6.1 472 - 474 ST KILDA ROAD MELBOURNE 1033/2018/A
LOCATION/ADDRESS: 472 - 474 ST KILDA ROAD MELBOURNE VIC 3004
EXECUTIVE MEMBER: BRIAN TEE, GENERAL MANAGER, CITY GROWTH AND DEVELOPMENT
PREPARED BY: ROSANNE MASSEY, PRINCIPAL PLANNER FISHERMANS BEND

- 1.1 To consider and determine a Section 72 Amendment Application (1033/2018/A) to amend an existing planning permit which includes deleting a level and increasing floor to floor levels (no change to height), layout changes, an increase in 12 dwellings and reduction in 20 serviced apartments, deletion of the food and drink premises, bar, restaurant, retail and office components, and revisions to the car parking provisions.

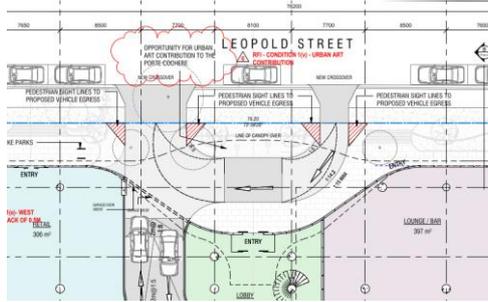
- 11.9 The proposed amendments do not include changes to the height or minimum setbacks. The built form changes would largely relate to the minor adjustments to the positioning of the four quadrants. The blue line within the below image from the advertised plans (TP-11-01) shows the limited changes proposed.

Loading bay

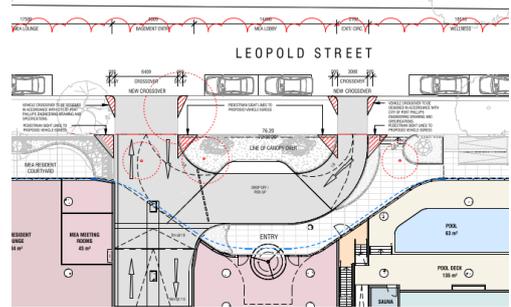
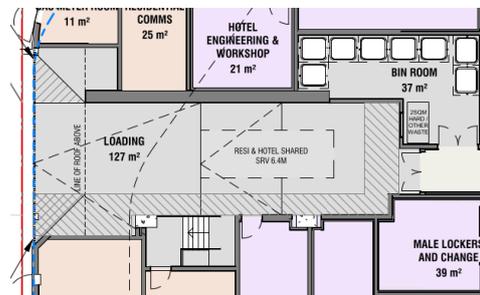
- 11.33 The loading bay design is proposed to be amended as detailed within the below images. The approved access via Queens Lane cannot be revisited and is not proposed to be altered, however the revised loading bay design and use requires assessment. The proposal seeks to amend the side by side spaces to one long singular space. The width of the loading bay access to Queens Lane was reduced through consultation at the Compulsory Conference. Given the crossover did not match the width of the loading bay area, it is extremely unlikely that two vehicles could have efficiently used the space at one time. As such the one long space would be acceptable, however it is suggested that the report clarify if the longer loading area is intended to be used as a tandem space, or if it would be for a single vehicle. It is assumed that it would accommodate one vehicle due for practicality, however this should be clarified. Refer to condition Condition 7e.

- 11.34 The loading bay would be 5m wide, would have a clearance of approximately 4.8m, and could accommodate accommodating 6.4m small rigid vehicles (SRV) for loading, waste collection and residential removalist services. A loading dock manager would be engaged by the building manager as detailed within the submitted Loading Dock Management Plan submitted with the application.
- 11.35 Within the Loading Dock Management Plan it is noted that the hours are yet to be determined, however the hours for the use must follow those already approved in the original permit which were imposed because of the consultation with objectors at the VCAT Compulsory Conference.
- 11.36 The revised design of the car parking within the basement levels, and slight re-positioning of the double crossover to Leopold Street would be acceptable as confirmed by Council's Traffic Engineer.

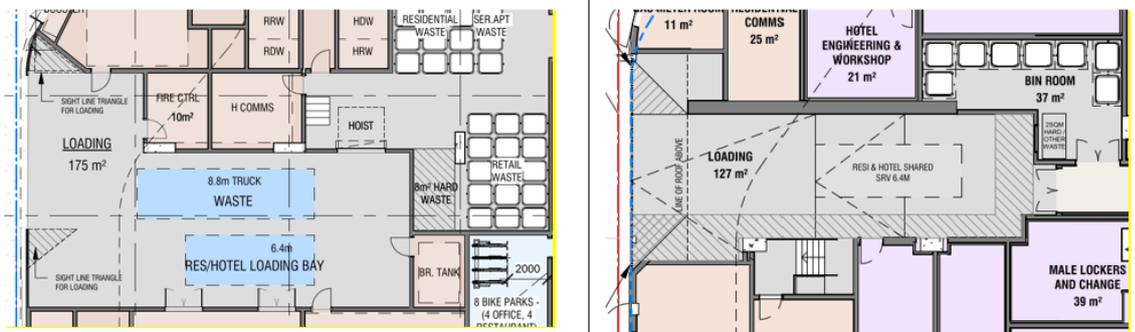
11.26 The revised dwelling layouts would maintain an acceptable level of compliance with Clause 58, consistent with the approved development. Revised dwelling layouts are a

result of the revised dwelling mix and are not significantly difference from the approved development. Cross ventilation, and minimum dimensions for a second bedroom would continue to have lower levels of compliance in comparison to the remainder of the proposal which would achieve high compliance rates often up to 100%. This is commensurate with the approved development, and in some instances better. The design of the internal privacy screens would be amended to maintain privacy for dwellings opposite each other within the development whilst maintaining the same level of internal amenity.
